Please Note*: Hegner's new XM18-265SN switches have two tabs and two screws, while some older machines used switches with only tabs. Naturally, customers try to use the two tabs to connect the new switch (or sometimes the two screws), but this will not work. Instead, you need to use one tab plus the screw connection on the same side of the switch (if your wiring has two clips this will require you to cut off one of the clips and strip the wire end to attach it to the screw).

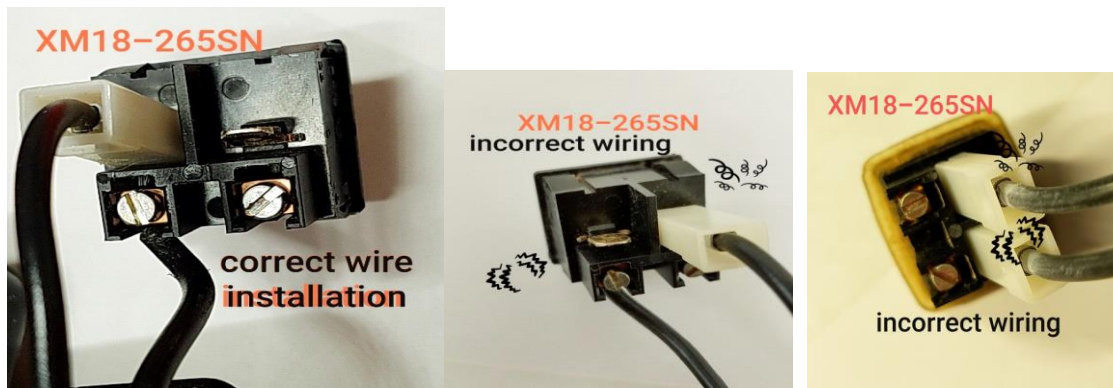
*(Left) For a single speed motor, follow the wiring as it was previously attached, to the new switch.
